Subject: Telecon Transmittal #10  
Comanche Peak Steam Electric Station  
Independent Assessment Program - Phase 3  
Texas Utilities Generating Company  
Job. No. 84042

Company:	Texas Utilities	<input type="checkbox"/> Telecon	<input checked="" type="checkbox"/> Conference Report
Project:	Comanche Peak Steam Electric Station Independent Assessment Program - Phase 3	Job No:	84042
		Date:	6/21/84
Subject:	Pipe Support Follow-up Questions	Time:	11:20 a.m.
		Place:	Site
Participants:	G. Grace, D. Rencher	of	TUSI
	J. Minichiello		Cygna

Subject CC-1-028-007-533R

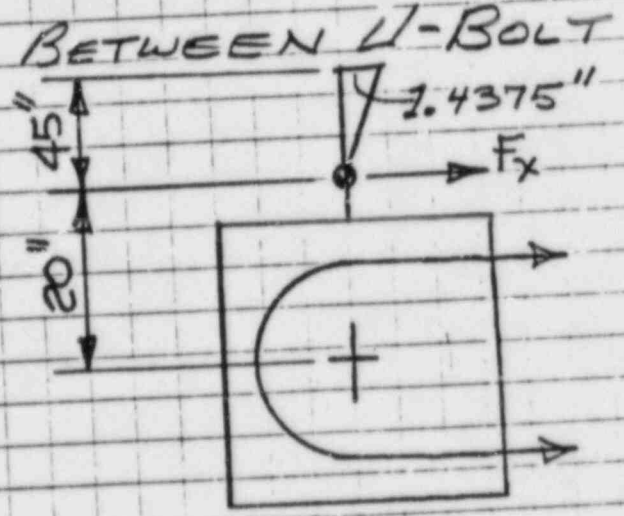
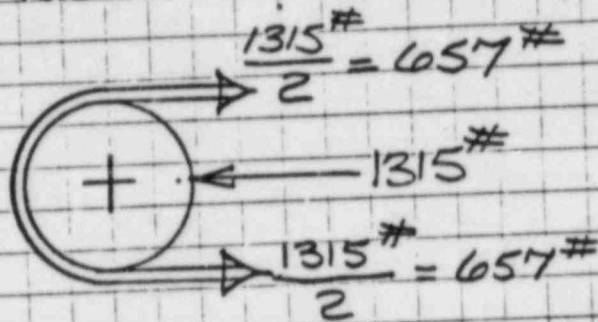
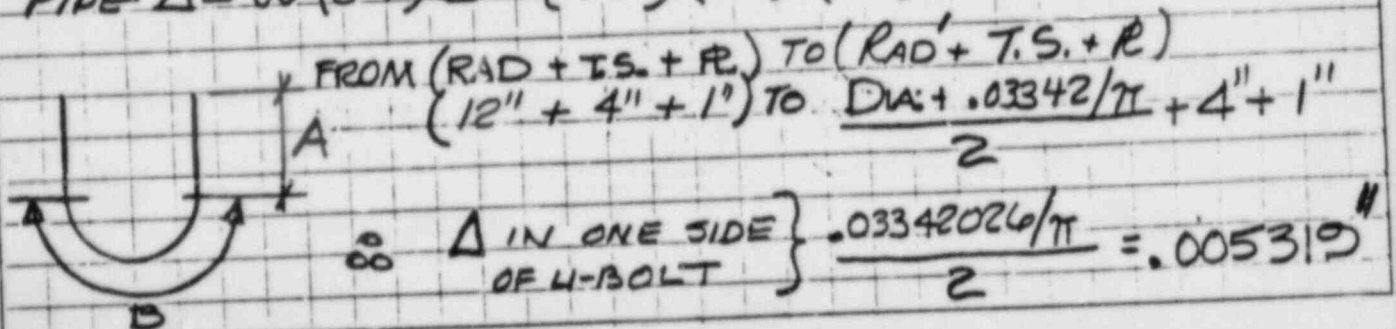
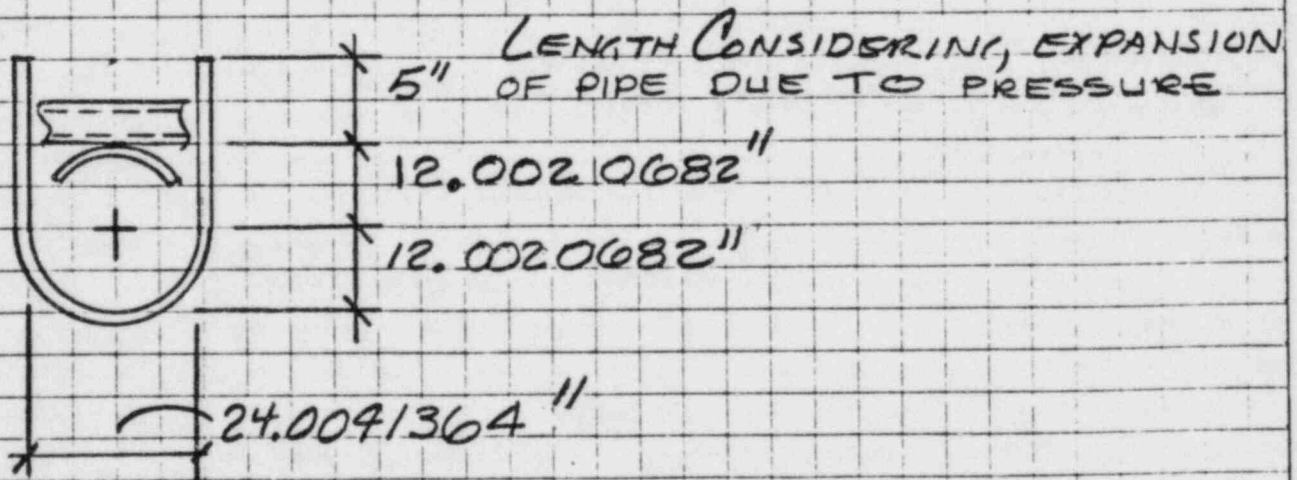
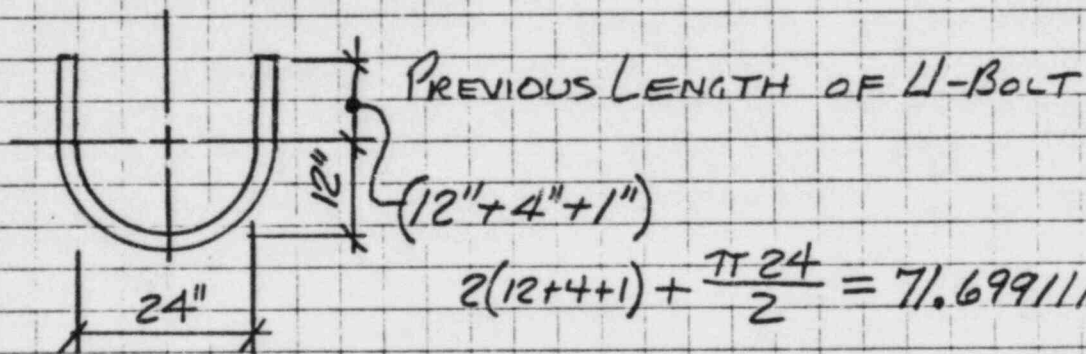
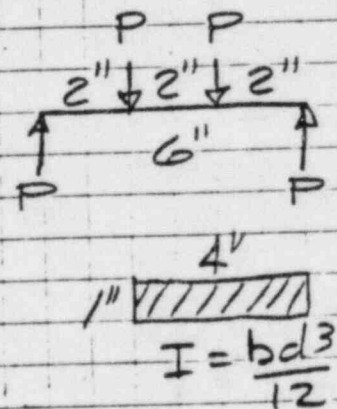
Item	Comments	Required Action By
	Texas supplied the attached calculation (CC-1-028-007-S33R) which was missing from Attachment C of TUGCO's 6/8/84 letter to Cygna.

**OBJECTIVES:** THE CALCULATIONS DATED 3/23/84, BY "A.T.", TO DESIGN U-BOLTS ADDED TO ENHANCE LATERAL STABILITY, HAD AN ERROR IN THE CALCULATIONS. ON PAGE 4 OF 6 OF THE REF'D CALCULATIONS, THE ASSUMED LENGTH OF THE U-BOLT IS NOT CORRECT. THE ERROR IS UNCONSERVATIVE, BUT BECAUSE OF OTHER CONSERVATIVE ASSUMPTIONS MADE ELSEWHERE IN THE CALC'S THE DESIGN IS STILL MORE THAN SUFFICIENT. THE FOLLOWING CALCULATIONS WILL DEMONSTRATE THAT.
